INLAND WETLANDS COMMISSION
TUESDAY, January 12, 2021
ZOOM Meeting

Town of Thompson
Inland Wetlands Commission
815 Riverside Drive
North Grosvenordale, CT 06255
860-923-1852 (Office) email: wetlands@thompsonct.org

**RIVERSIDE DRIVE (ROUTE 12)
 SIDEWALK REPLACEMENT**

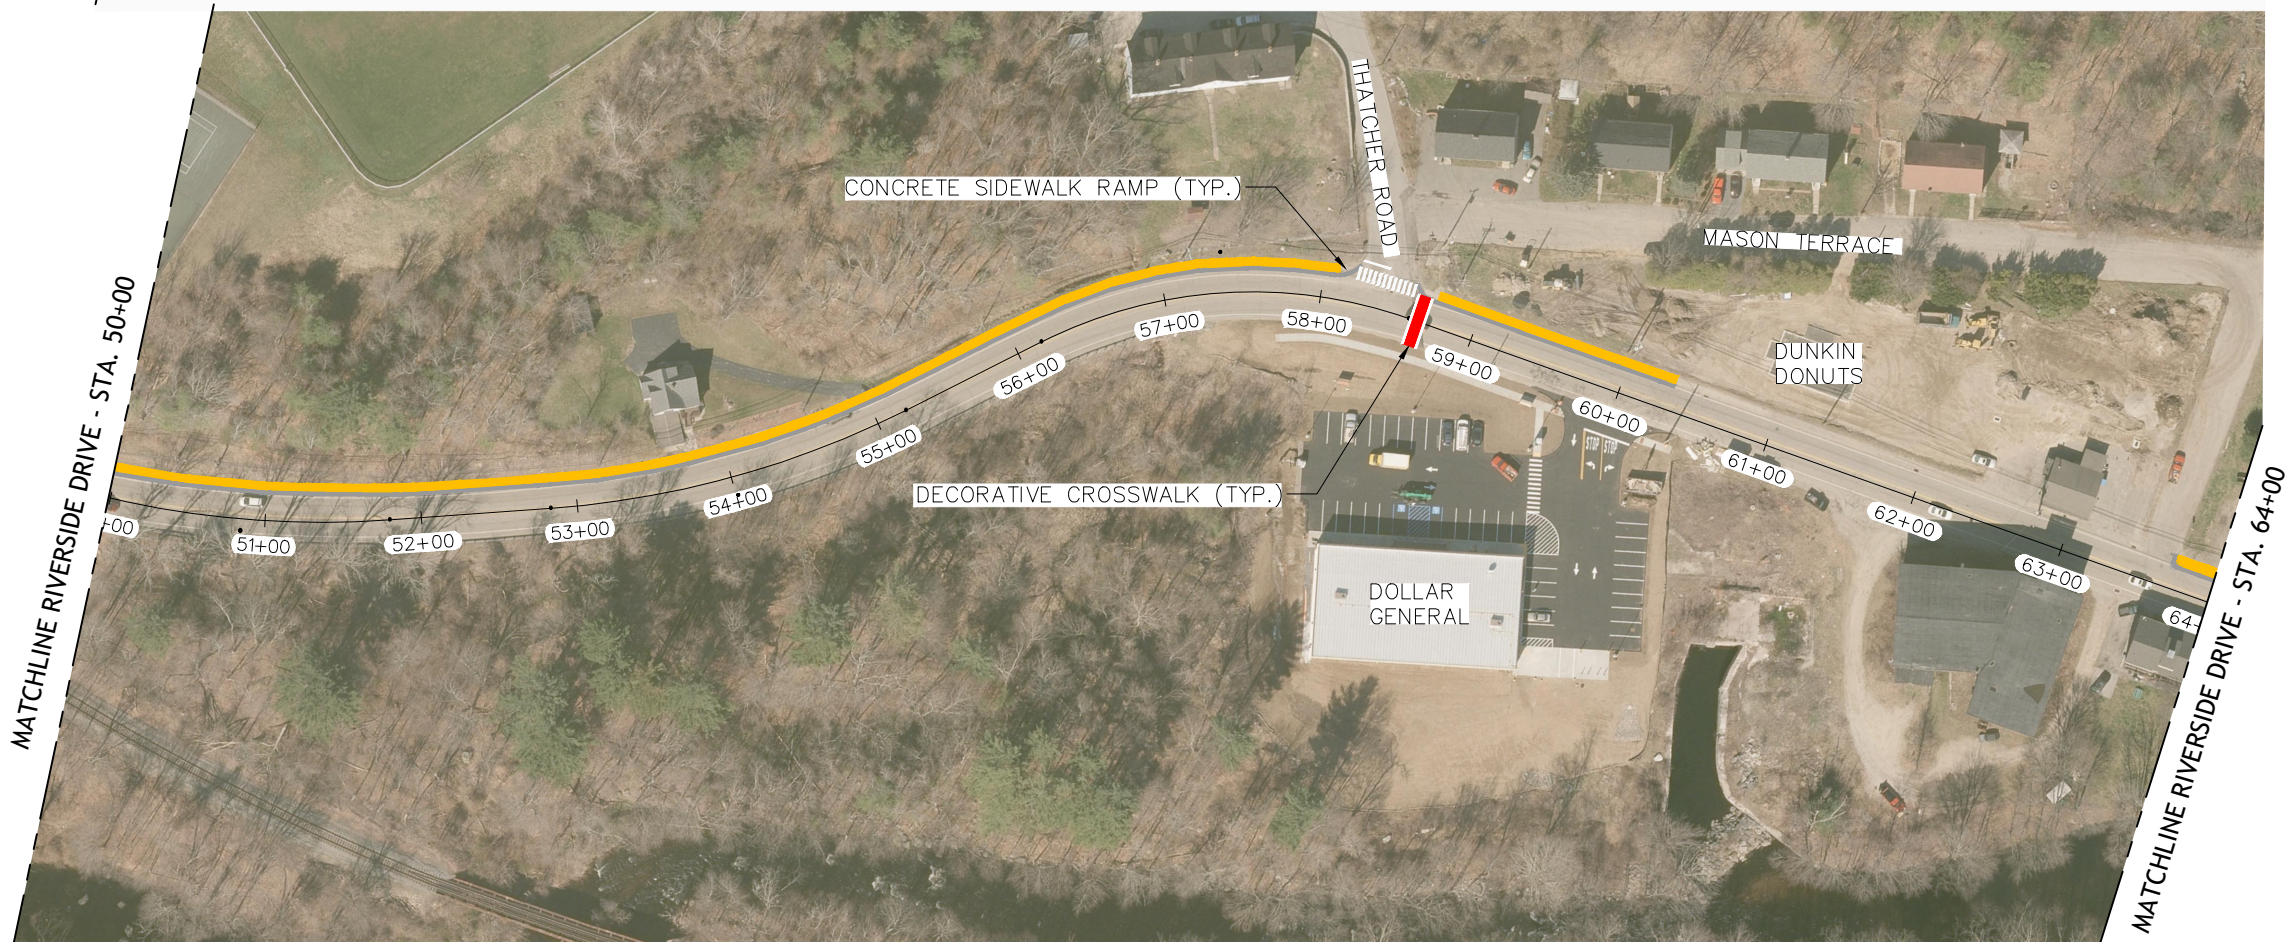
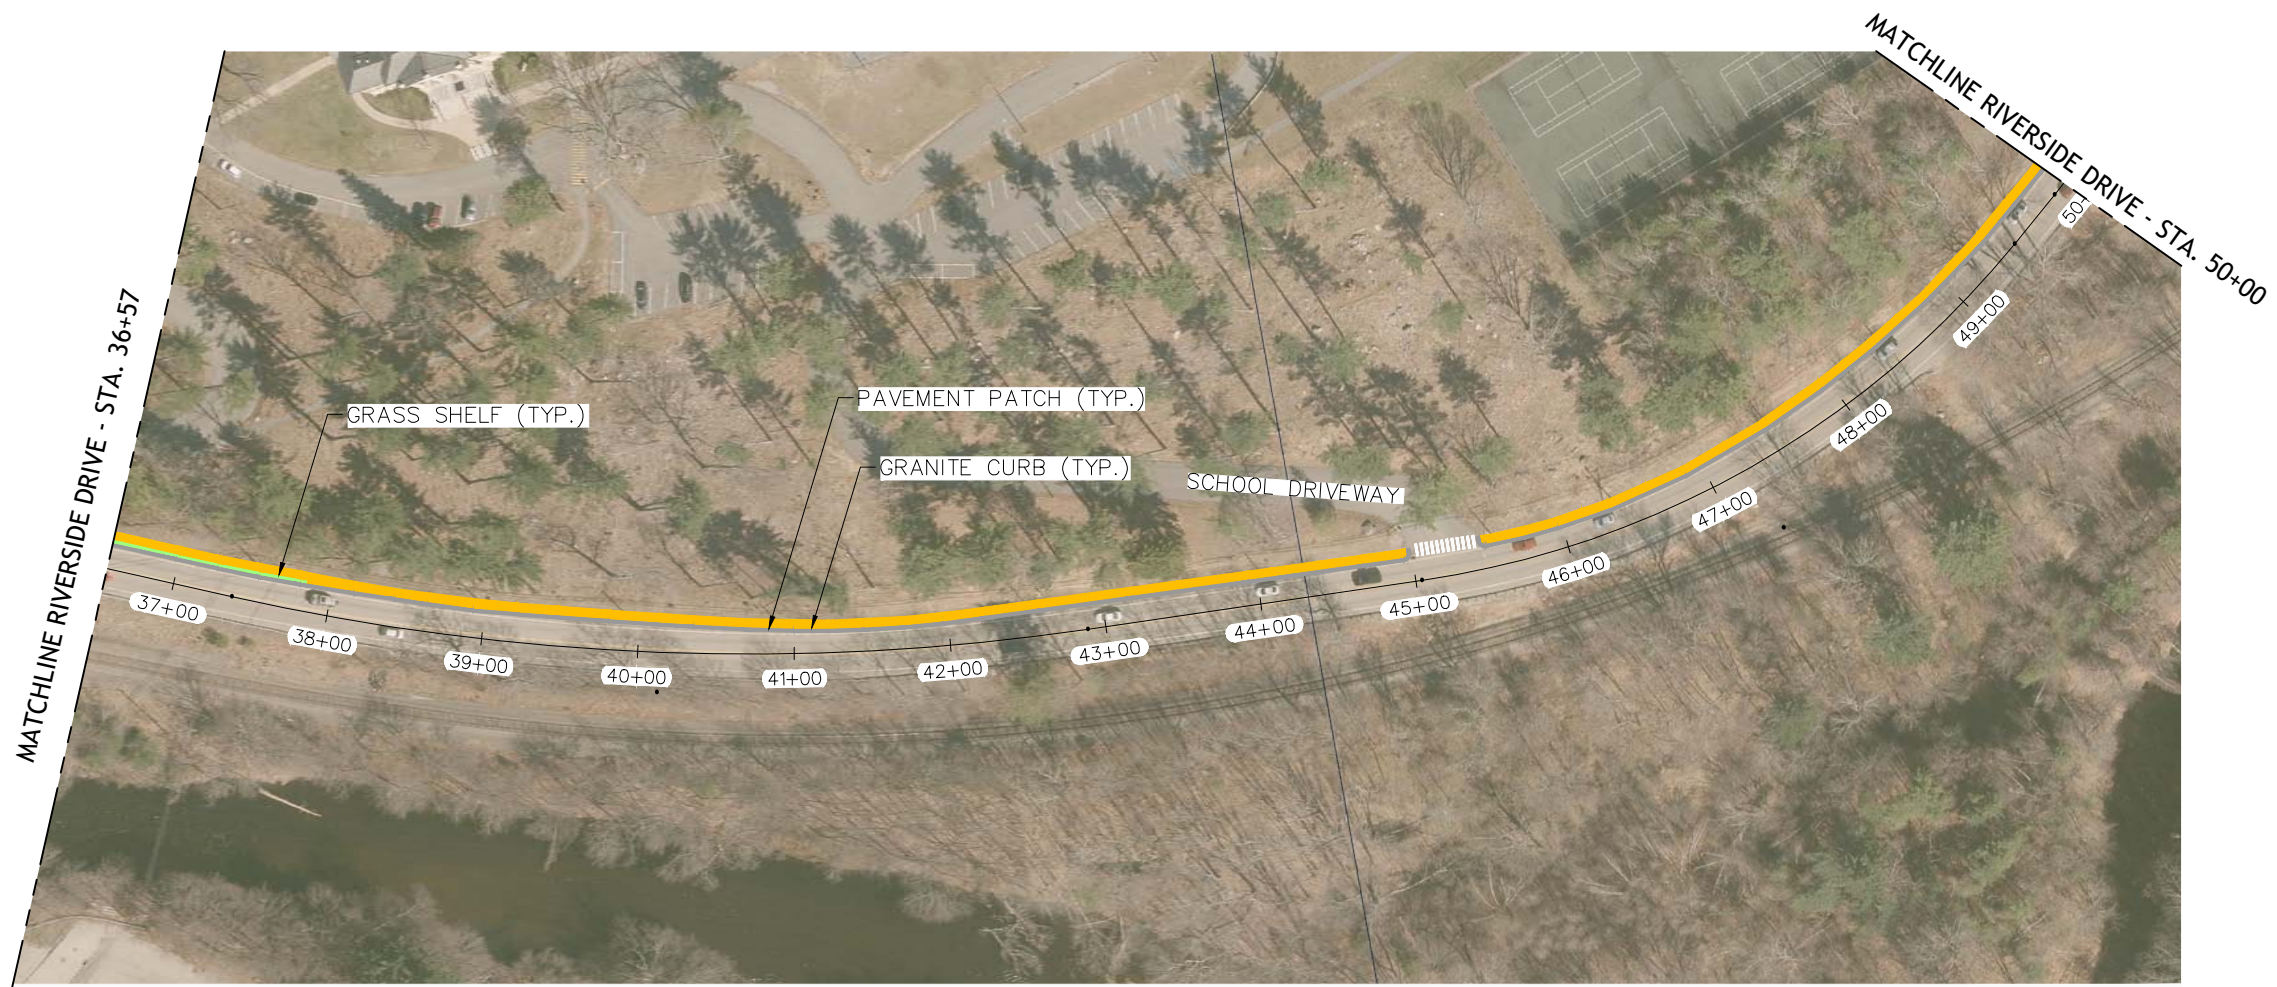
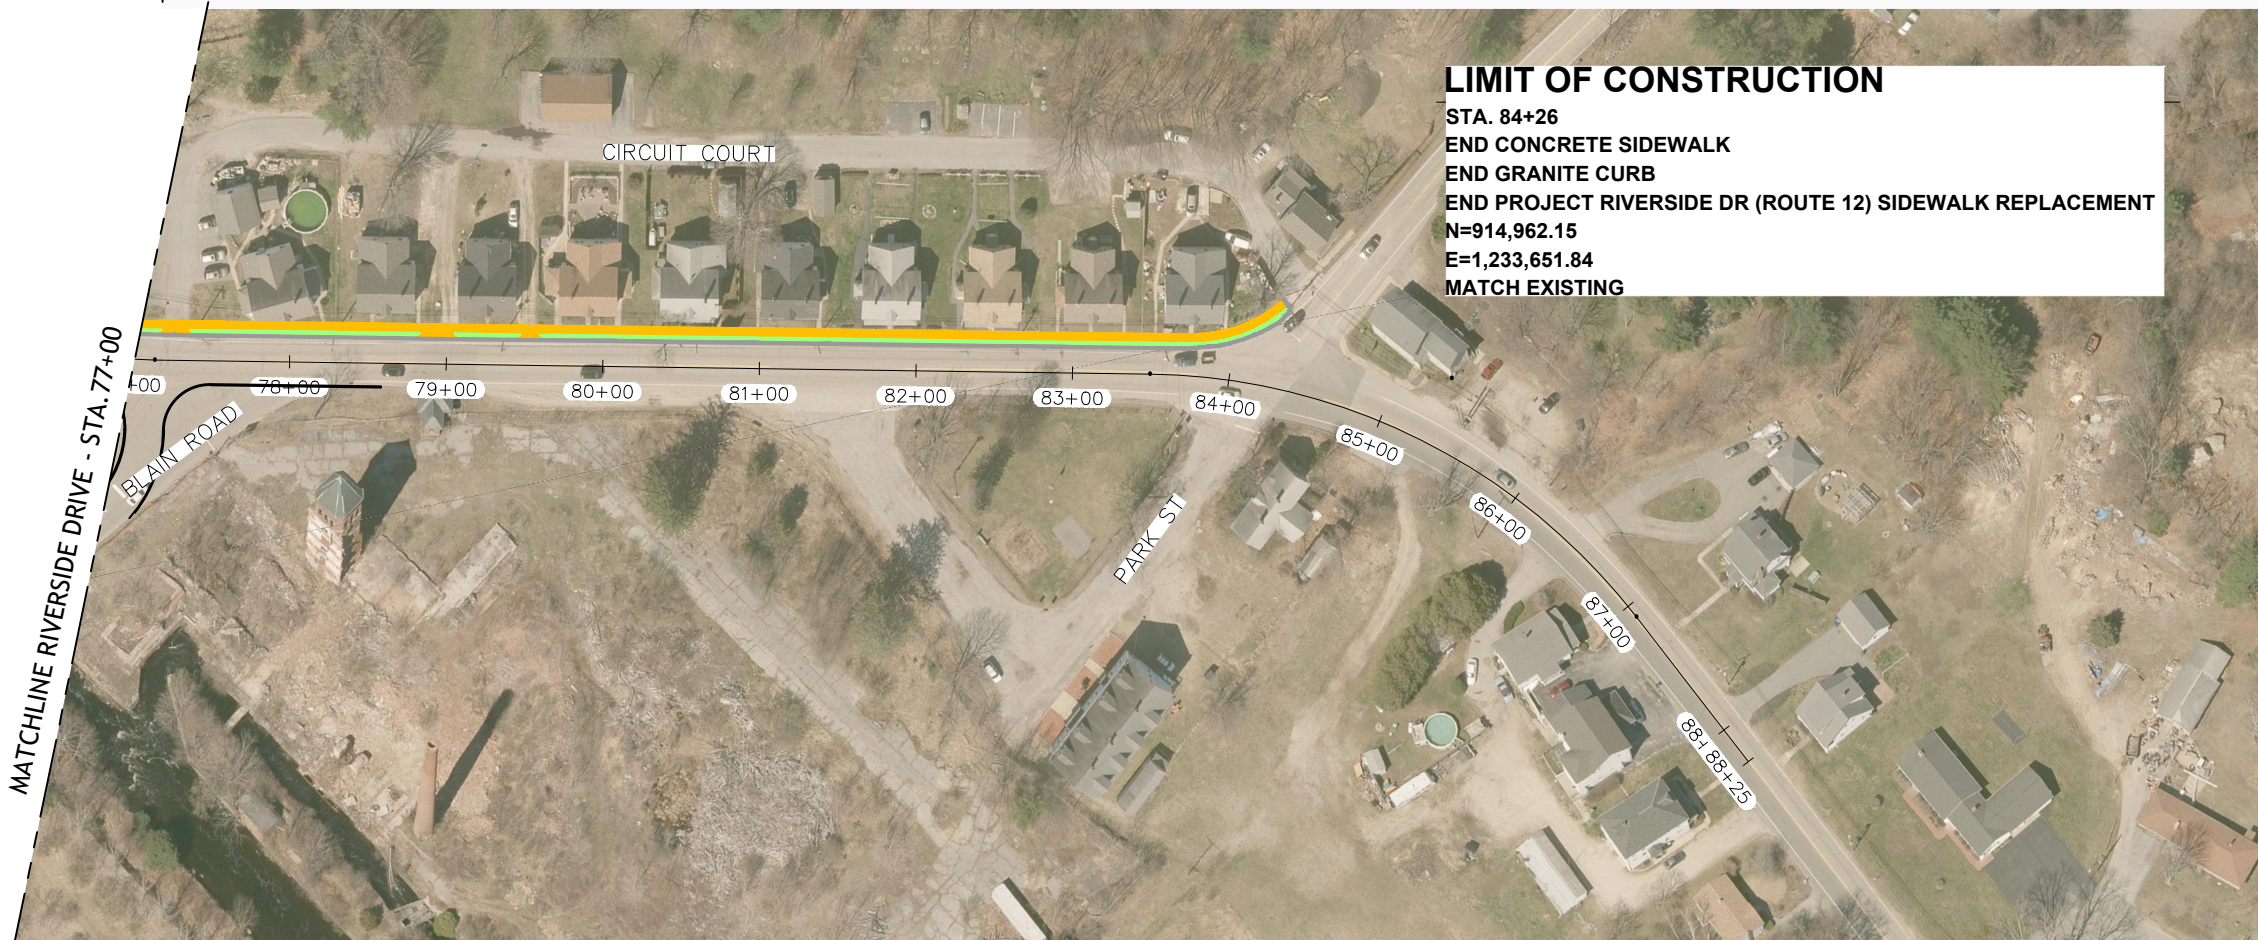
The proposed project consists of sidewalk replacement. The only drainage improvement proposed is to replace CB tops since it is a state owned system. However, we acknowledge that it will be beneficial if the sidewalk project can help reduce drainage problems in this area. Freeman Companies offered the following suggestions. They will put a note on the plans requiring the contractor to clean out the pipe. They will also "tweak" the grading in that flat area to help direct runoff into the CB's. In addition, the next time our consultant takes a final walk through the site he will evaluate the structure behind the sidewalk and see if there are any straightforward solutions for improvements. We aren't sure that a simple solution will be identified, but it will at least be investigated. We will let you know what the findings are.
